Bramley House

6th April 2022

Bramley Proposed Scope of works

Proposal: Installation of sedum blanket green roof system and Photovoltaic (PV) panels (also called solar electric panels); raising the balustrade height and parapet wall height by 230mm; and raising the balconies' metal handrails by 200mm to meet current Building Regulations

Proposed Green Roof Plan

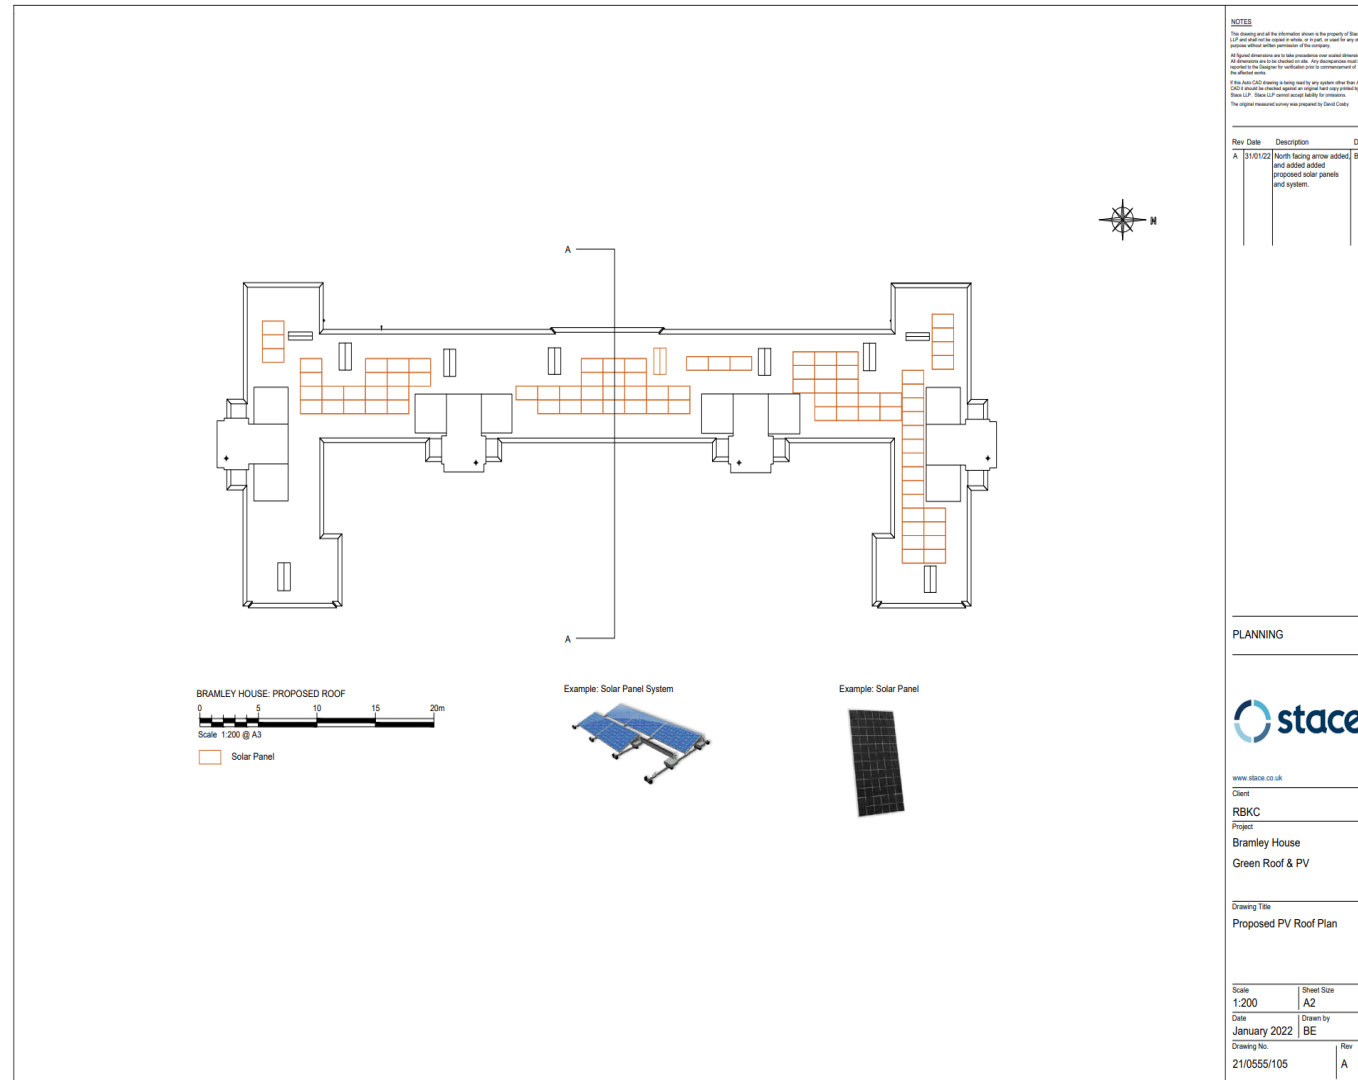
Cracks from roof to ground floor. 10 flats badly effected

Impact of sedum blanket roof on building

Flooding is a great concern because no professional has given us any assurance that this will not happen. Vermin from the pigeons on balconies , roof and roof garden, rats.

Comment received: Dear Planning, Re. proposed GREEN ROOF We support the installation of solar panels on the roof of Bramley Hse. But why do we need a sedum blanket green roof?

Comment received: I am a leaseholder of Bramley House and I have not been given sufficient information on the roof planned. Not one leaseholder wants a green roof we just want the roof replaced with proper insulation and solar panels, leaseholders and tenants took part in the book of ideas at no point was a green roof discussed or approved. What was discussed was to reintroduce a roof terrace area which was taken away from residents years ago without their consent or pre warning. W11 nor the Residents Association have given residents a chance to question the planning application and to find out what could happen if the roof fails what damage that could cause to the block and its residents? what the cost difference is in providing a green roof as opposed to a well insulated fibre glass roof?, what is the difference in insulation benefits that this green roof would provide as opposed to a non green roof (well insulated fibre glass flat roof)?, what are the anticipated/estimated differences in the costs of living for each household (eg; energy savings) this roof is expected to provides residents on the 3 floor and lower compared to their costs of living now? How much money can be saved and used towards other much needed capital works like the repointing of brickwork or insulation of the concrete floors and ceilings of the flats by not doing a living green roof but doing a well insulated fibre glass flat roof? Also does this roof attract pigeons? Pigeon droppings contain a fungus called Cryptococcus that can cause infections in vulnerable people if inhaled, is there any research been done into the likelihood of more wildlife being attracted to the block that could lead to higher cleaning charges because of bird droppings? I would also like to know what the annual maintenance charges will be for the upkeep of the roof, will it increase service charge bills and if so by how much as a percentage of recent charges. More information needs to be provided and the questions above need to be answered before this roof is installed and for the above reasons I strongly object as a leaseholder and resident. I would happily support a safe roof terrace with a better insulated flat roof than currently exists with solar panels.

Comment received: Dear Planning, Further to my earlier comments and questions. I object to this application because there is not enough information and there are too many unanswered questions. In particular who will pay for the ongoing maintenance of the sedum blanket and solar panels. Re. raising the balcony heights. Where is the requirement, legal or otherwise, for the retrospective application of building regs?

There is also an objection sent directly to me which I've asked Support to upload about whether the roof could withstand the weight of the proposed sedum roof and PV panels as the resident states the building is old and cracking – can you confirm it would be a lightweight

Prior to installing the new SBS elastomeric bitumen membrane with sedum green roof, the deck and structure will be checked to confirm it is sound and durable.

All structural cracks will be rectified as part of the works.

There is no reason to suggest the deck is not in a suitable condition. Concerning the failure of the waterproofing, i.e., roof coverings, we are aware that the existing roof covering, although replaced in more recent years (approx. 20 years ago) has failed. This has been reported as a failure of the roof covering and not the structural deck below. A number of defects are present with the roof covering, to name a few: blistering, defective laps, membrane becoming brittle and de-bonded surfaces. The new system will be provided with a 30 year independently insured workmanship and materials guarantee. We are not aware of any major vermin or pigeon infestation that effects Bramley House and this is not an issue previously raised. We don't except any increased risk of vermin on site, as a result of the green roof installation.

Response: We would firstly advise that none of these issues are planning matters and should not be considered in determining the application. The sedum blanket has been chosen as it will require minimal maintenance. RBKC will need to advise on who pays for ongoing maintenance., including the PV panels. We have addressed the issue of the parapet elsewhere in our response.

Response: We would firstly advise that none of these issues are planning matters and should not be considered in determining the application. Prior to installing the new SBS elastomeric bitumen membrane with sedum green roof, the deck and structure will be checked to confirm it is sound and durable. There is no reason to suggest the deck is not in a suitable condition. Concerning the failure of the waterproofing, i.e., roof coverings, we are aware that the existing roof covering, although replaced in more recent years (approx. 20 years ago) has failed. This has been reported as a failure of the roof covering and not the structural deck below. A number of defects are present with the roof covering, to name a few: blistering, defective laps, membrane becoming brittle and de-bonded surfaces. The new system will be provided with a 30 year independently insured workmanship and materials guarantee. All structural cracks will be rectified as part of the works as explained. The roof has been reviewed by a qualified Structural Engineer and the additional loading imposed has been assessed and is suitable. See our earlier comments on the pigeons.

The roof has been reviewed by our Structural Engineer and the additional loading imposed has been assessed and is suitable.
